SSM's external experts' review of SKB's
safety assessment SR-PSU - hydrogeology,
geochemistry and bentonite
Main review phase

SSM's external experts' review of SKB's
safety assessment SR-PSU - hydrogeology,
geochemistry and bentonite

Review of hydrogeological aspects of the safety assessment SR-PSU – Main review phase

Activity number: 3030014-1029
Registration number: SSM2017-1003
Contact person at SSM: Georg Lindgren

Figure 2.1: Realizations of the DFN model ranked by the sum of the transmissivity of stochastic fractures intersecting the rock vaults of SFR 1 and SFR 3. From Figure 4-5 of TD05 (SKBdoc 1395200).

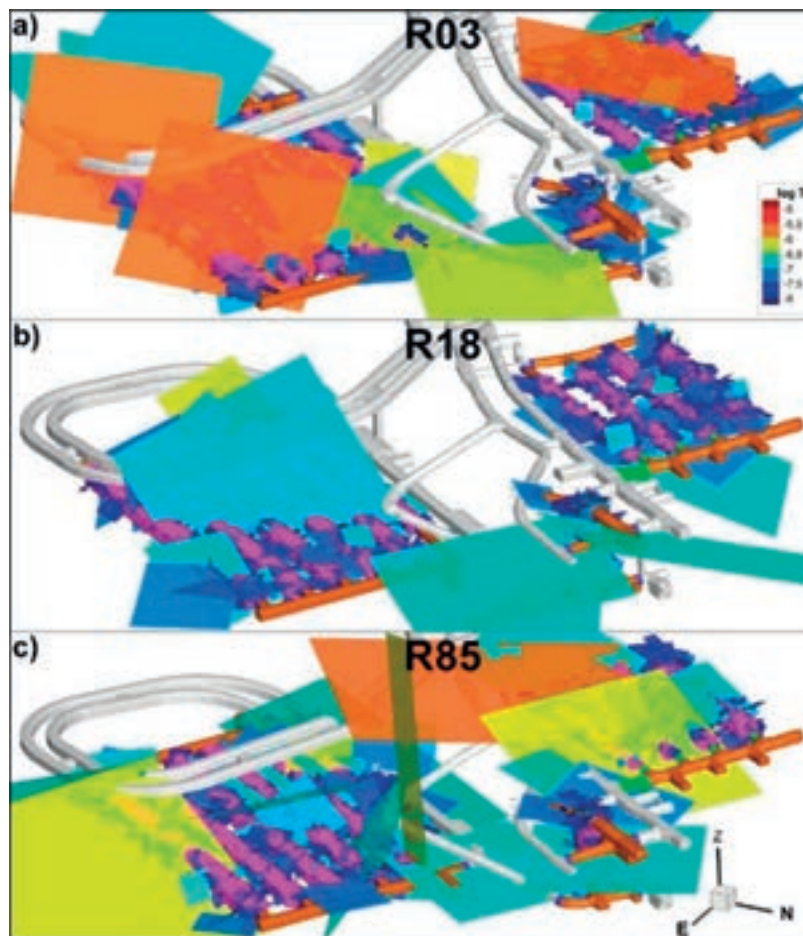
Realization R85 was in fact ranked the highest by all of these measures. However from Figure 2.1 it can be seen that the sum of transmissivity of intersecting fractures is within a span of one order of magnitude for all 99 realizations that were analysed, and most of the realizations are within half an order of magnitude of the maximum value. Thus in terms of net transmissivity, the selected “pessimistic” realization, R85, does not show an overwhelming contrast with most of the other realizations. An additional HRD realization, R03, was selected based on an assessment that it was “pessimistic” for the SFR 3 vaults 4BLA, 5BLA and 2BMA, as well as SFR 1 vault 1BMA (Odén et al., 2014). The rationale for selecting this realization is not discussed in SKBdoc 1395200.

Figure 2.11: Scale factors for near-field flows for each waste vault used for the *high flow in the bedrock* scenario. Based on Figure 7-13 of TR-14-01.

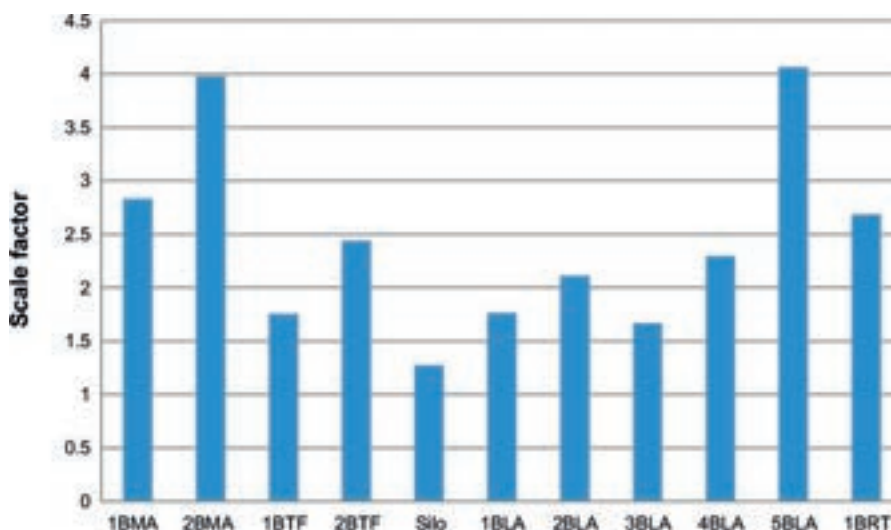
The Main Report (TR-14-01) notes that some of the scale factors in Figure 2.11 result from calculation cases other than the “high-flow” bedrock case (bedrock case 11). Thus the total aggregated flow through the waste vaults in this scenario is higher than calculated in any of the bedrock cases.

Considering this last point in particular, the possibility cannot be discounted that a substantial percentage of the 96 HRD realizations that were not evaluated by flow simulations would yield higher flows to one or more of the vaults, even in excess of the scale factors in Figure 2.11. Therefore the assertion that the probability for the *high flow in the bedrock scenario* is “considerably less than 10%” is poorly supported by the evidence that has been presented.

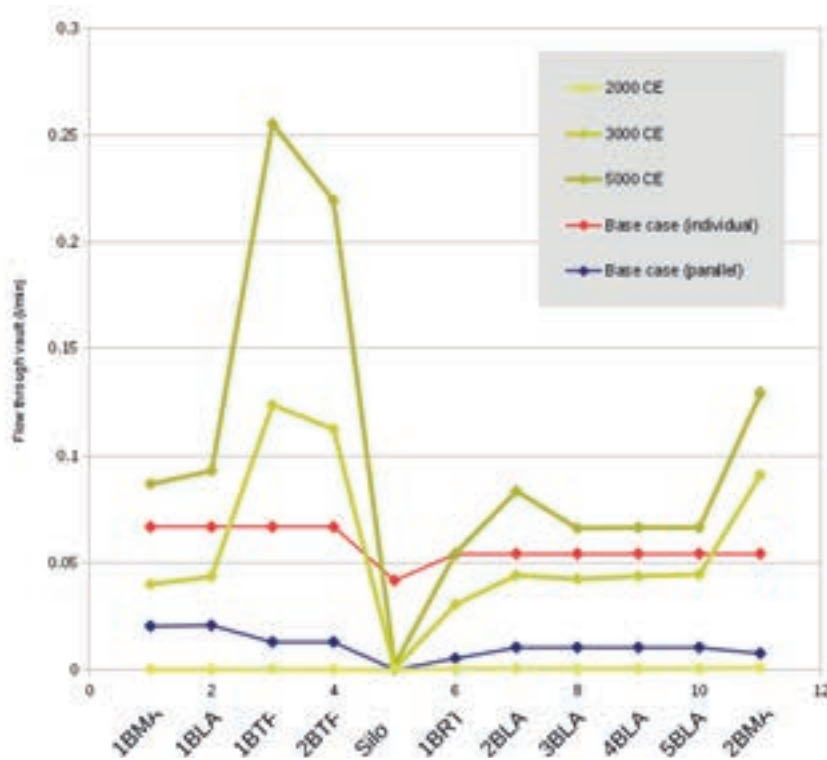
Results for the base case of the simplified model are compared with SKB's results for SR-PSU in Figure 2.13.

For most vaults, the results for these two different assumptions bracket the flowrates calculated in SKB's model for times approximately 1000 years after present (3000 CE), at which point the Baltic has retreated sufficiently for the assumed value of Δh to be realistic. The exceptions are 1-2BTF and 2BMA, where SKB's calculations exceed the simplified model results by less than a factor of 2.

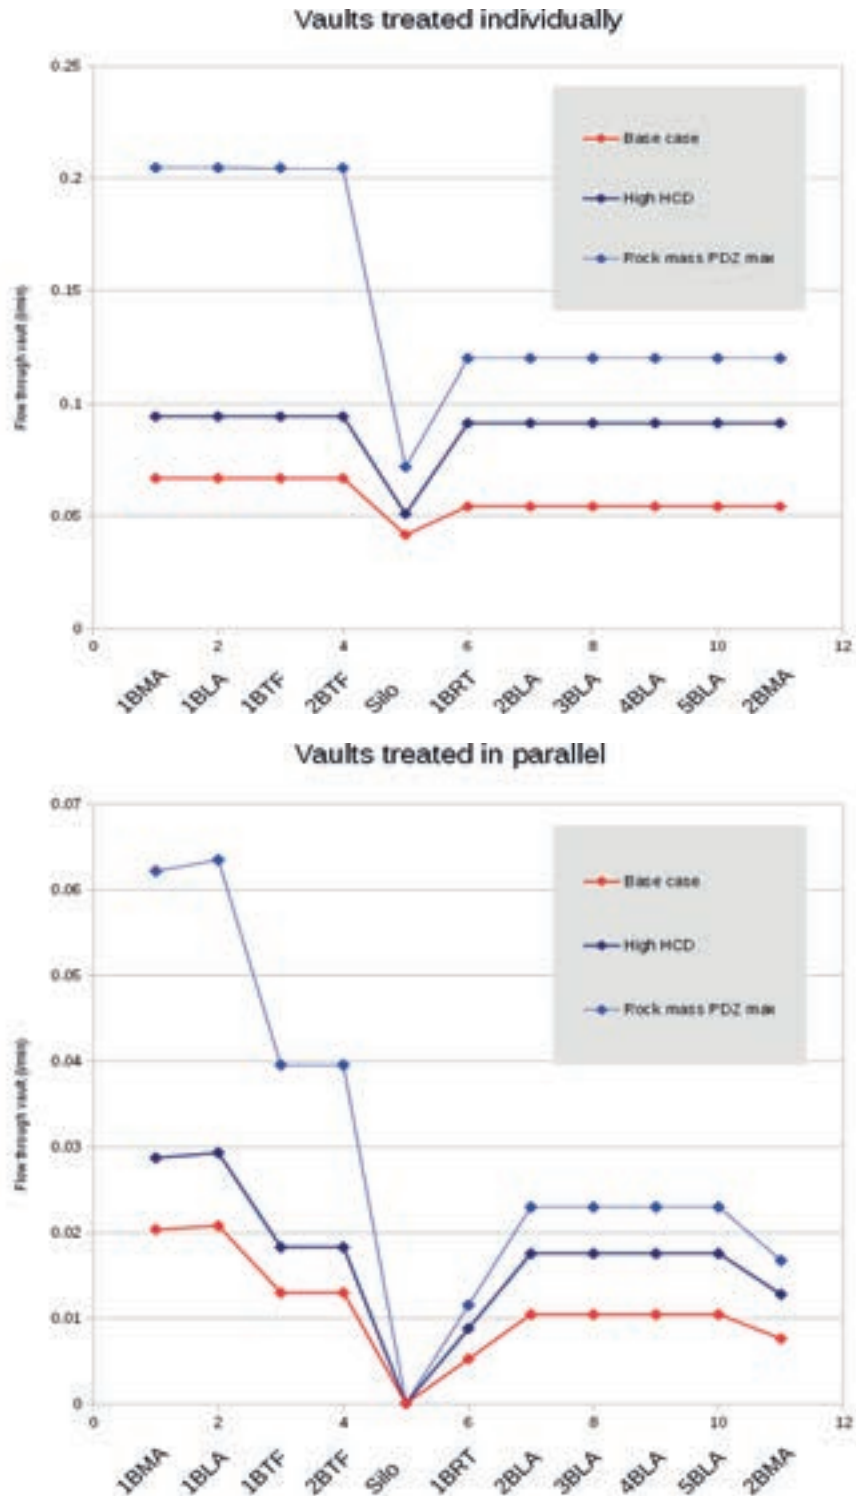
Results of this calculation case are compared with the base-case results in Table 2.6 and Figure 2.14 (together with results of another case related to deterministic HCDs, discussed in the next section). Direct connections through the rock mass via high-transmissivity PDZs could potentially increase flows to vaults in SFR1 by a factor of 3, and flows to vaults in SFR3 by a factor of 2.2, relative to the base case.

The results as shown in Figure 2.14 are an increase in flowrates, relative to the base case, by roughly 40% for the SFR1 vaults by 70% for the vaults in the proposed new facility. The greater effect for the latter is a consequence of its greater depth, as this implies a longer path through HCDs and thus a proportionally greater distance over which HCD transmissivity limits flow, in this simplified model.

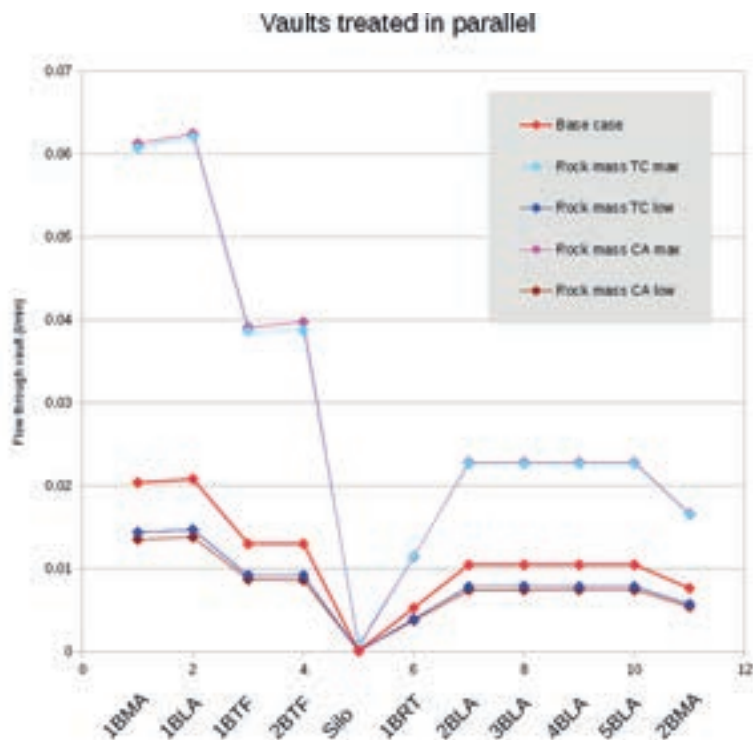
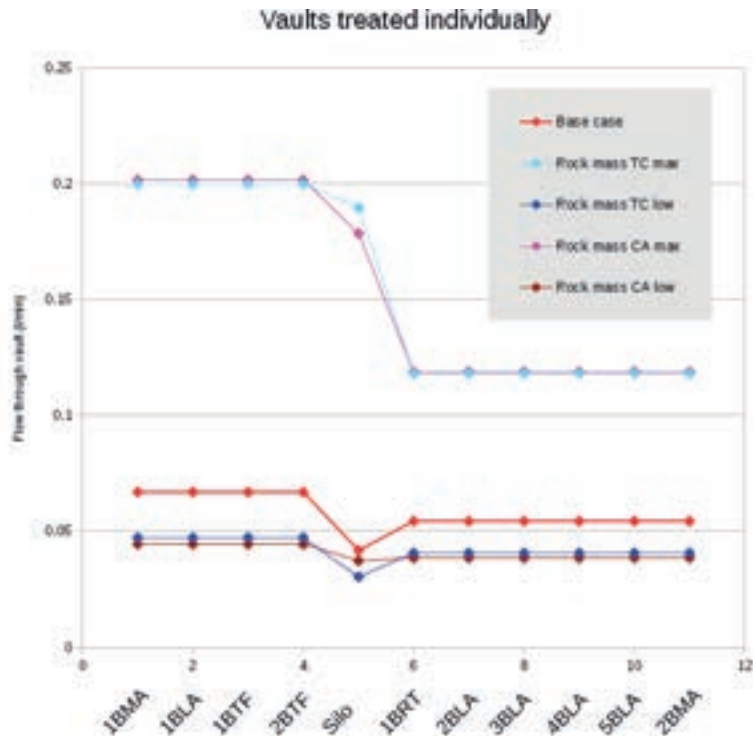
The results are shown in Table 2.7 and Figure 2.16. The differences between the connectivity-analysis model and the tectonic-continuum model are very slight. For both models, the maximum increase in flow relative to the base case is roughly a factor of 3 for the vaults in SFR1, and a factor of 2.2 for the vaults in SFR3. Thus the maximum flows resulting from connections via relatively high-conductivity portions of the bedrock, with an ECPM representation based on the DFN models, is similar to the effect of direct connections through the rock mass via PDZs.

The connectivity-analysis model produces a slightly wider range of flowrates for a given vault. This can be explained in terms of the observations from Figure 2.15, that the connectivity-analysis model has a slightly more low- K_g blocks relative to the tectonic-continuum model, but also a slightly higher number of high- K_g blocks with $K_g > 2 \times 10^{-7}$ m/s.

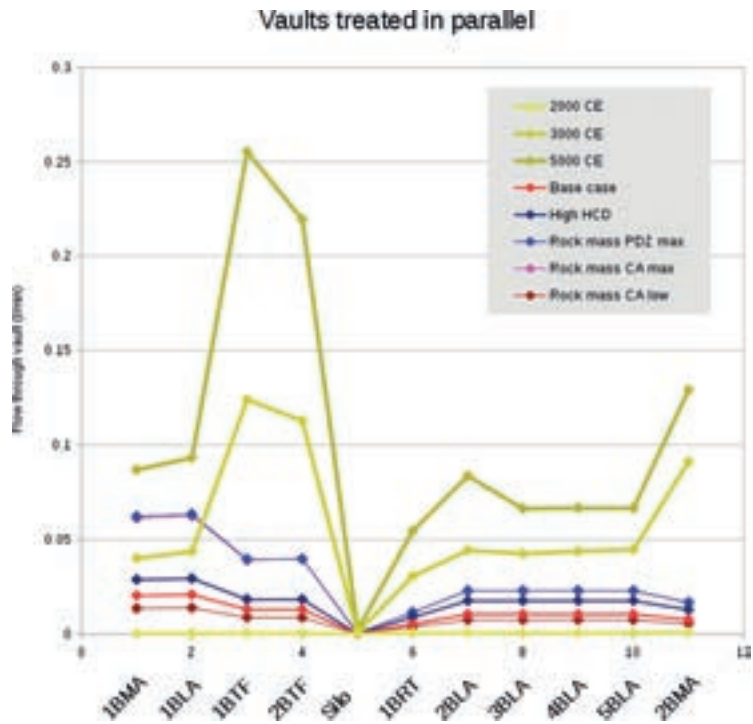
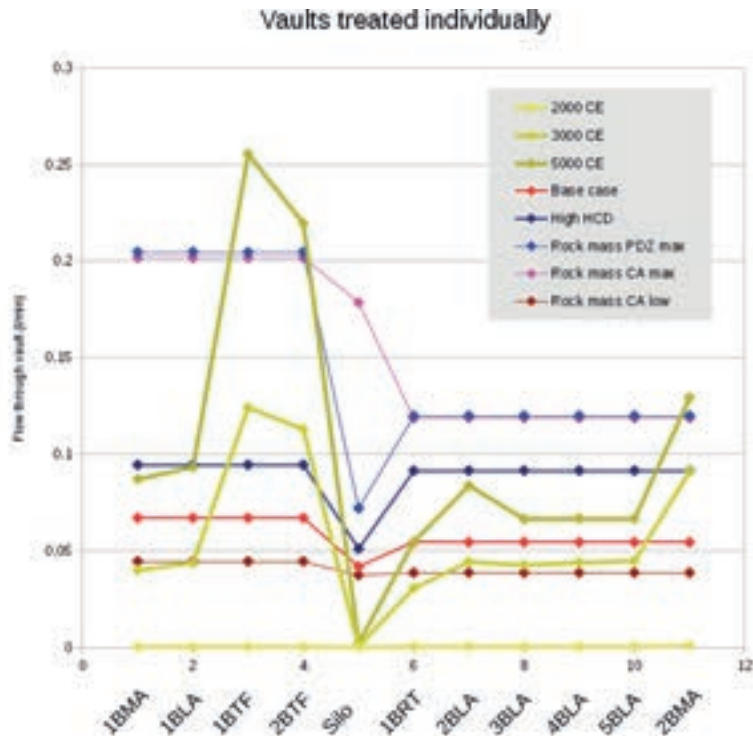
The main results from the simplified model are summarized in Table 3.1, and compared in Figure 3.1 with the flows predicted by SKB's modelling for present-day and future temperate-period conditions.

Combinations of geosphere variations with alternative parametrizations of degraded/cracked barriers have not been evaluated.
